TRAILS AT ASPEN RIDGE FILING NO.2

EL PASO COUNTY, CO

ROADWAY & STORM IMPROVEMENT PLANS

JUNE, 2020

TRAILS AT ASPEN RIDGE
FILING NO. 2
ROADWAY & STORM IMPROVEMENT PLANS
ROADWAY GENERAL NOTES
DESIGNED BY: NMS, SCALE: N/A, DATE ISSUED: JUNE, 2020, DRAWING No: GN01
DRAWN BY: CRD, HORIZ: N/A, SHEET: 2 OF 36
CHECKED BY: NMS, VERT: N/A

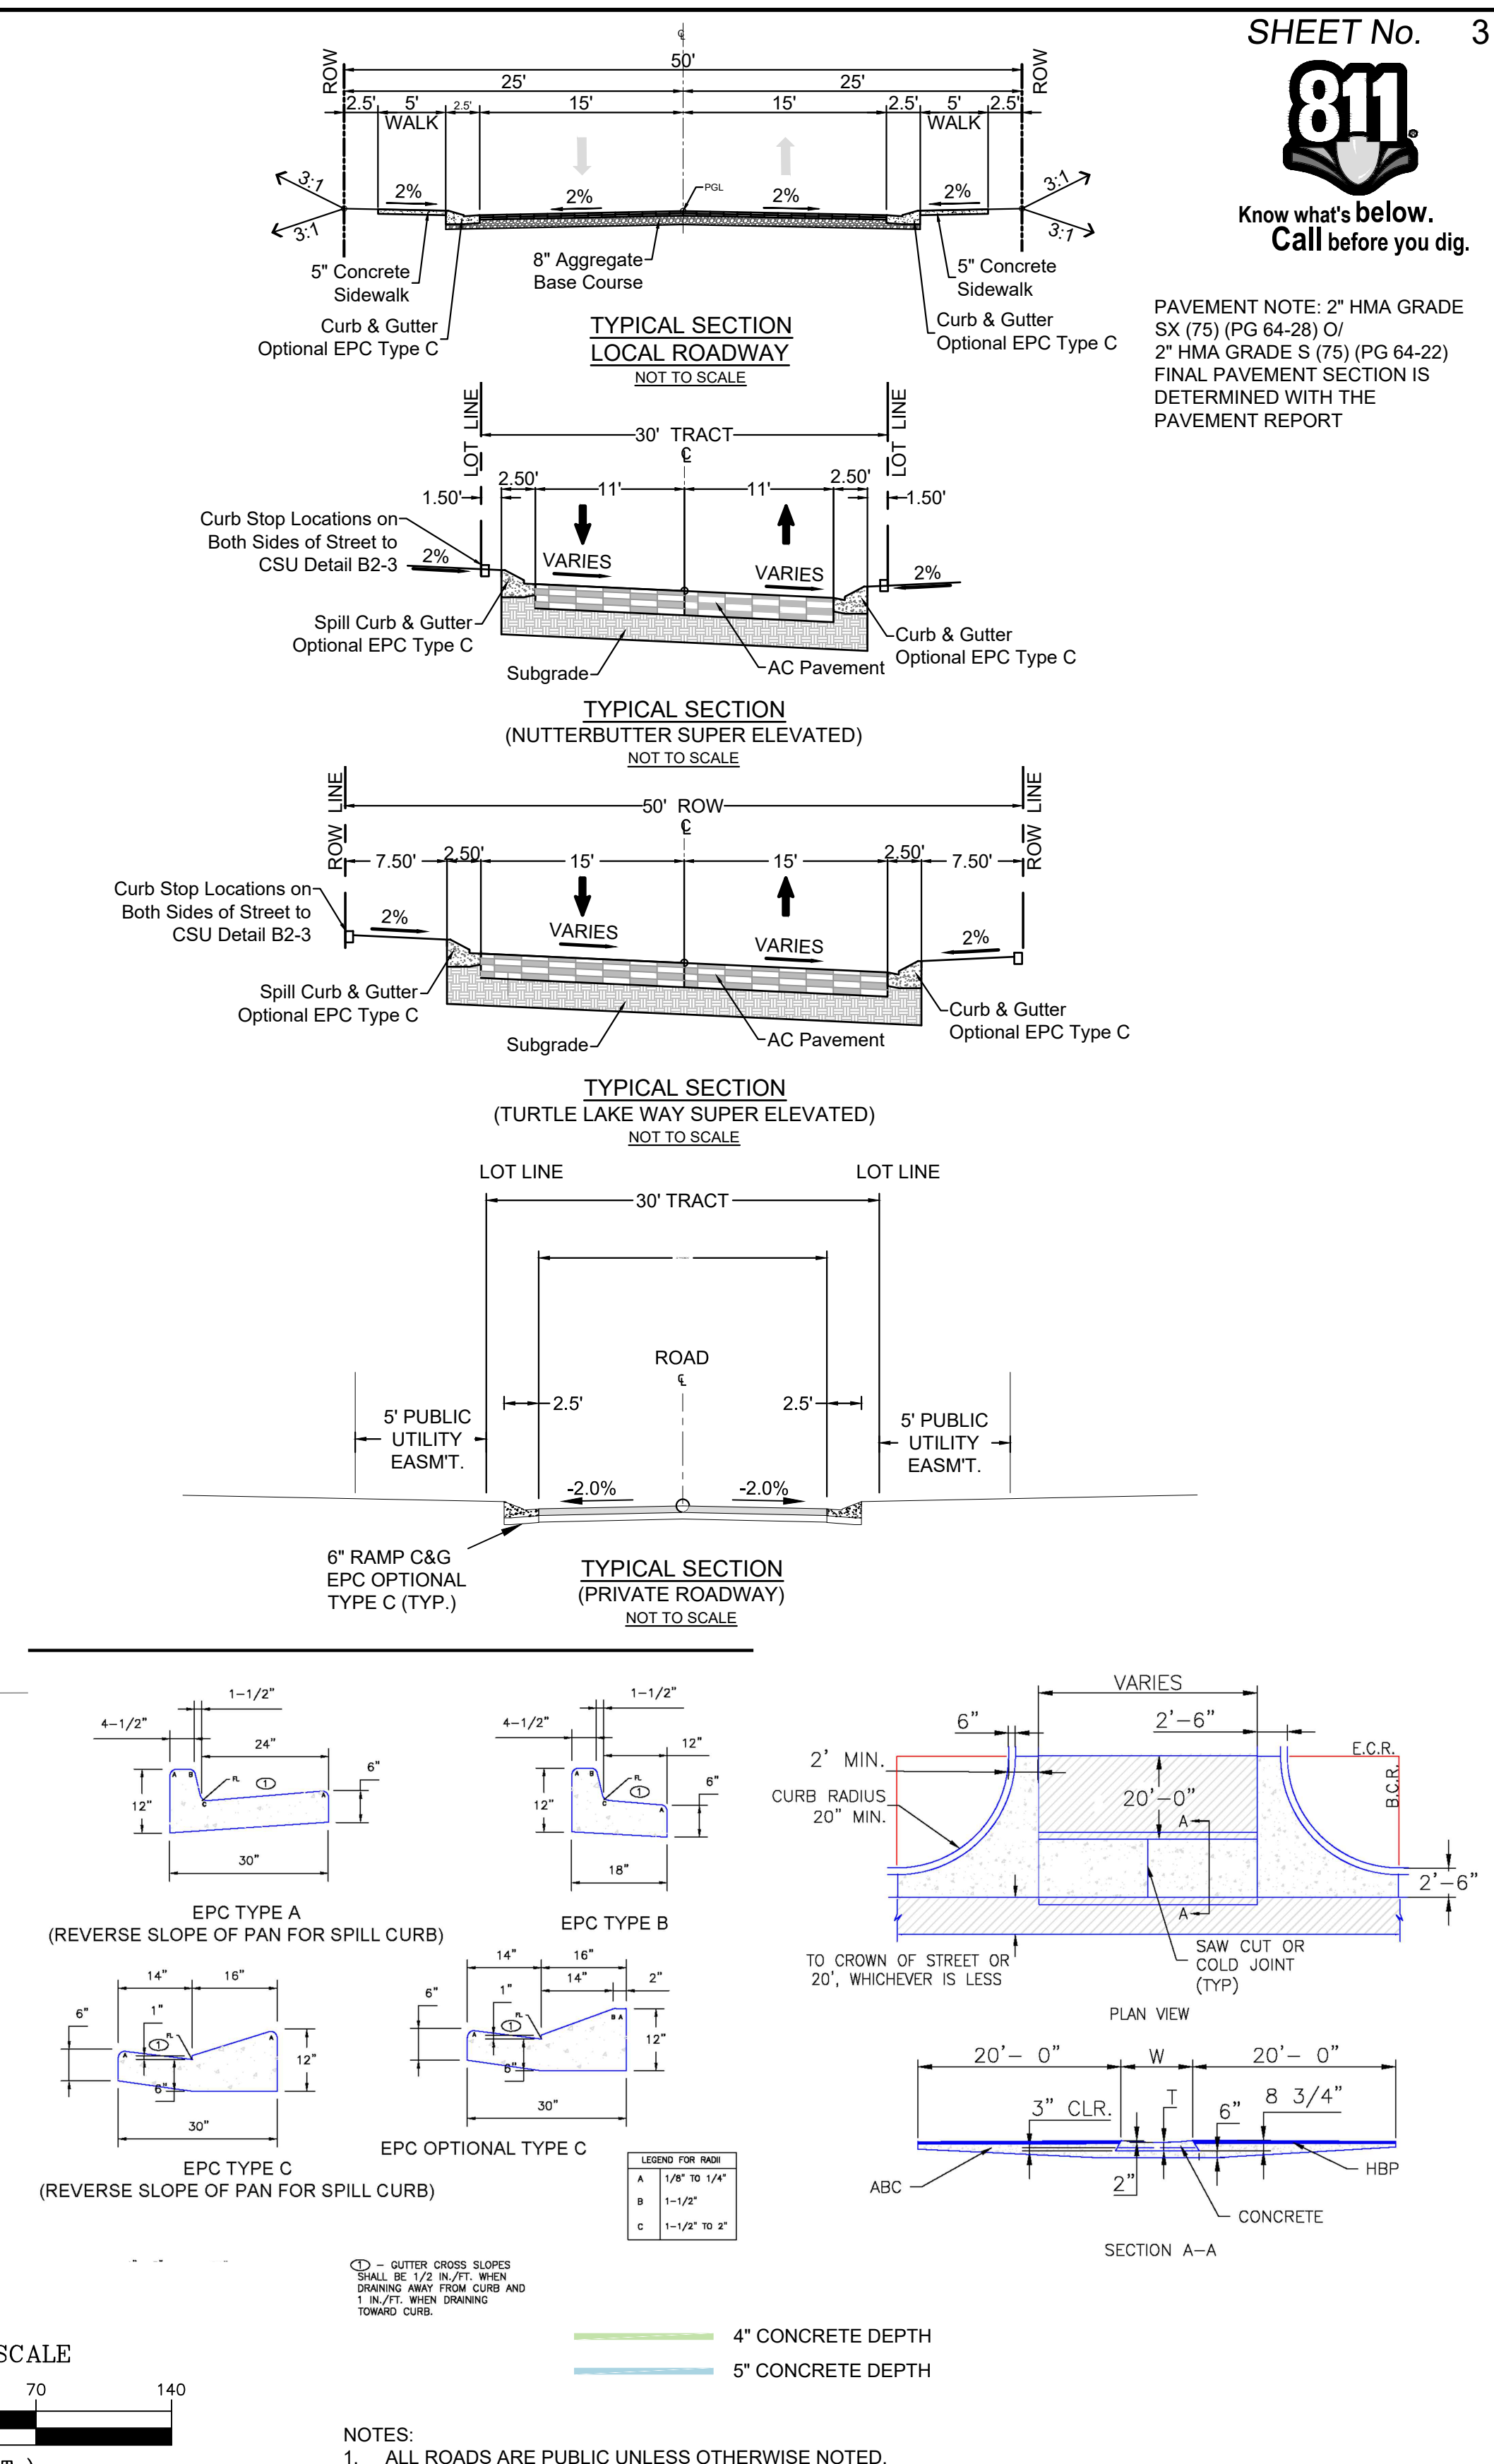
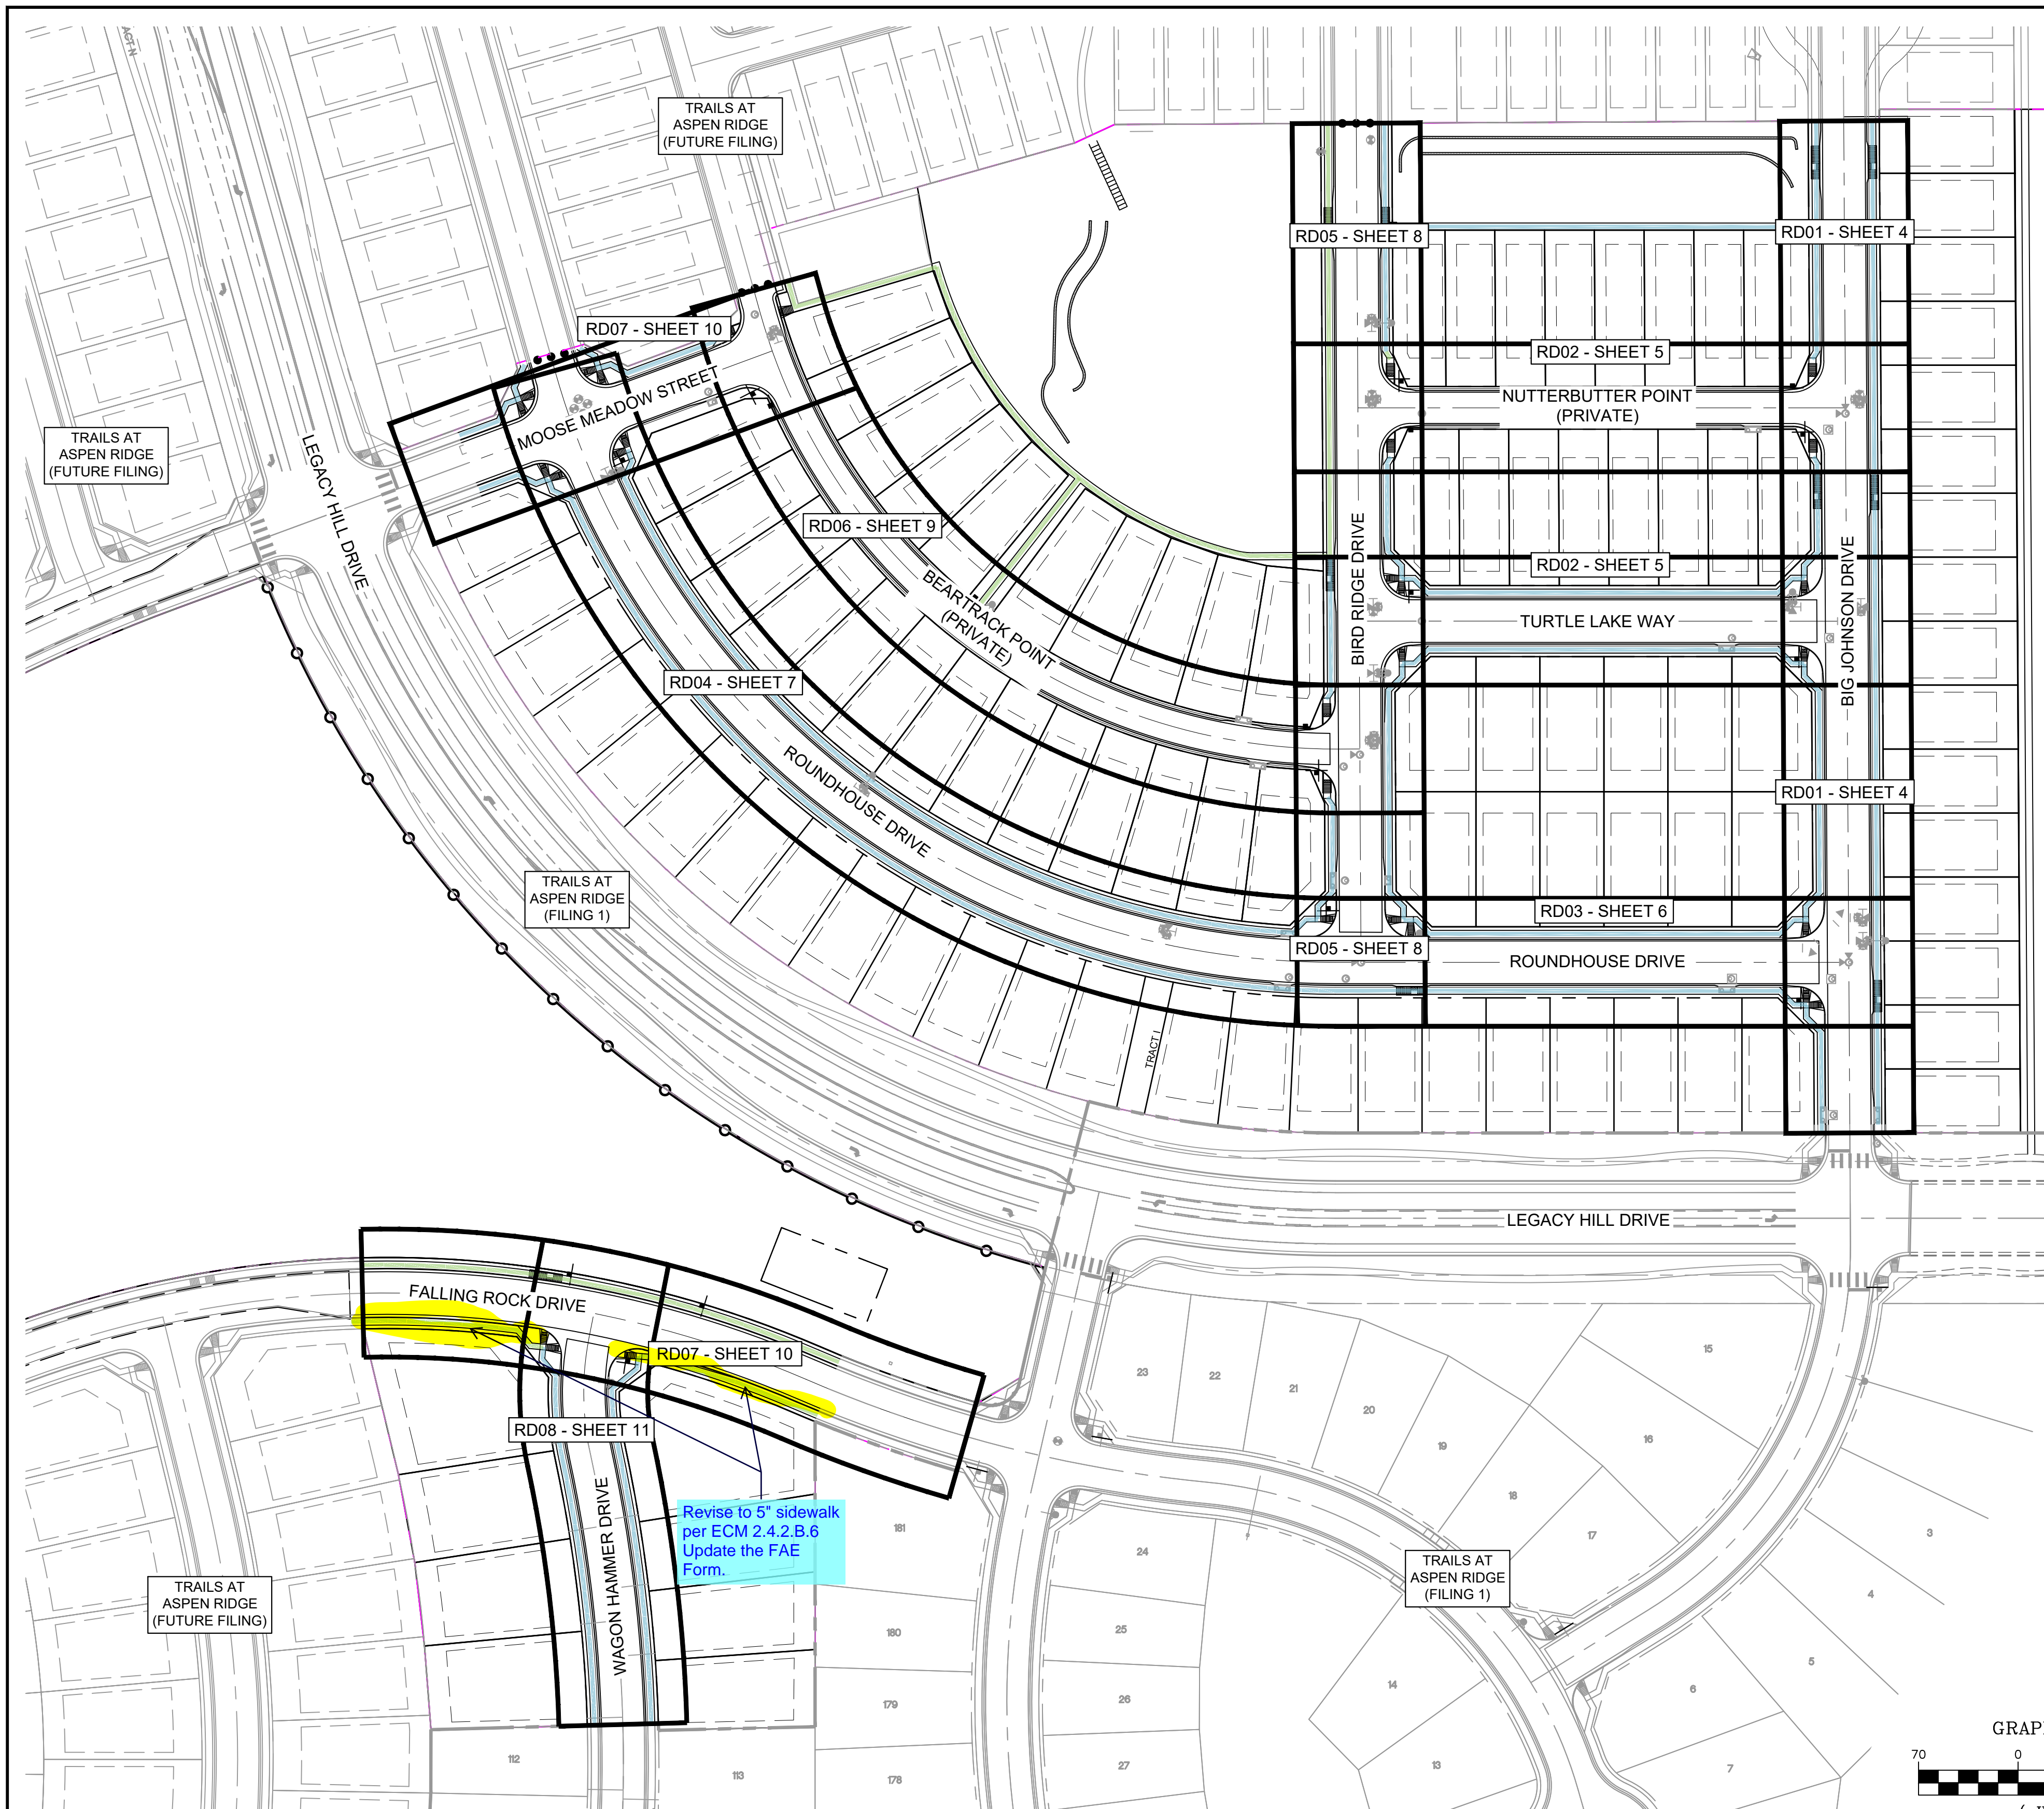
Revise to 5" sidewalk per ECM 2.4.2.B.6 Update the FAE Form.
